LYLE MACHINERY CO. SUBDIVISION

APPLICATION NUMBER 1 DATE August 4, 2022

APPLICANT Lyle Machinery Co. Subdivision

SITE PLAN

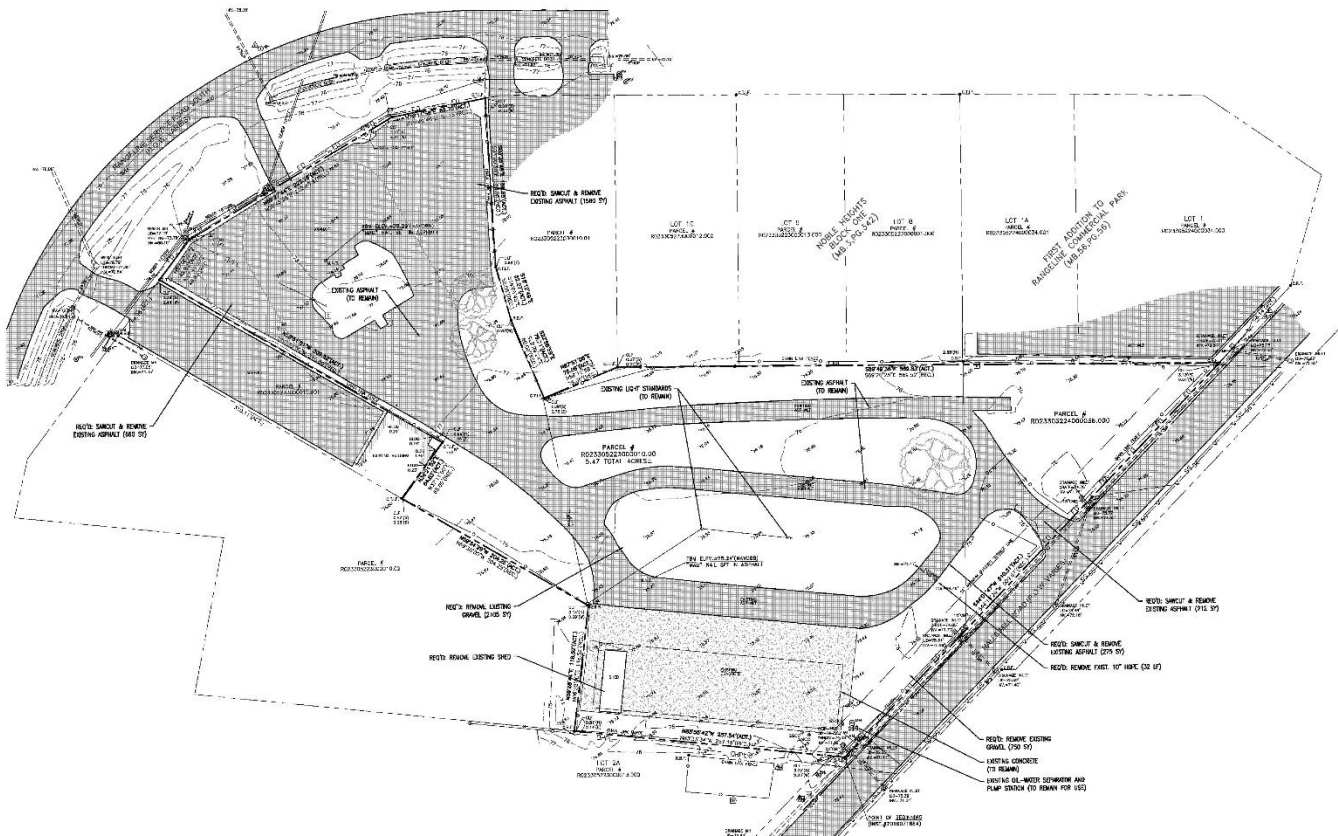
The site has frontage on Halls Mill Road, a minor arterial road included in the Major Street Plan, with a required 70-foot right-of-way at this location. The site has additional frontage on Rangeline Service Road South, a marginal access street with a required 40-foot right-of-way. The preliminary plat lists both street's rights-of-way as "varies", and as such, should be revised on the Final Plat to illustrate compliant right-of-way widths labeling each width from the center line. *Existing minimum right-of-way widths must be depicted on the final plat. If the right-of-way width does not meet the minimum required by the Major Street Plan, dedication will be required.*

The plat indicates a 25-foot minimum building setback line along Halls Mill Road which should be retained on the Final Plat, adjusted for dedication if approved. No minimum building setback is shown along Rangeline Service Road South. As such, if approved, the Final Plat should be revised to include a compliant setback along both frontages, adjusting for dedication as needed. The proposed lot meets the minimum size requirements of the Subdivision Regulations. As on the preliminary plat, the lot size label in both square feet and acres should be retained on the Final Plat, or a table should be furnished on the Final Plat providing the same information, adjusted for dedication, if approved.

It should also be noted that neither the preliminary plat nor the site plan submitted to staff illustrates a sidewalk along either Halls Mill Road or Rangeline Service Road South. Sidewalks are required along the street frontages of all new developments and redevelopments within the city, per the Subdivision Regulations, and as required by the City's Complete Streets Policy adopted by City Council in 2011. As such, a sidewalk should be constructed along Halls Mill Road and Rangeline Service Road South at the time of development; or, the applicant may request Sidewalk Waiver Approval from the Planning Commission to waive this requirement.

- 1) revision of the Final Plat to illustrate the right-of-way width for Halls Mill Road as 70', adjusting for dedication as needed;
- 2) revision of the Final Plat to illustrate the right-of-way width for Rangeline Service Road South as 40', adjusting for dedication as needed;

- 3) revision of the Final Plat to illustrate a compliant 25-foot minimum building setback line along Rangeline Service Road South, adjusting for dedication as needed;

- 4) retention of the 25-foot minimum building setback line along Halls Mill Road on the Final Plat, adjusted for dedication as needed;
- 5) retention of the lot size label in both square feet and acres on the Final Plat, or the furnishing of a table on the Final Plat providing the same information;
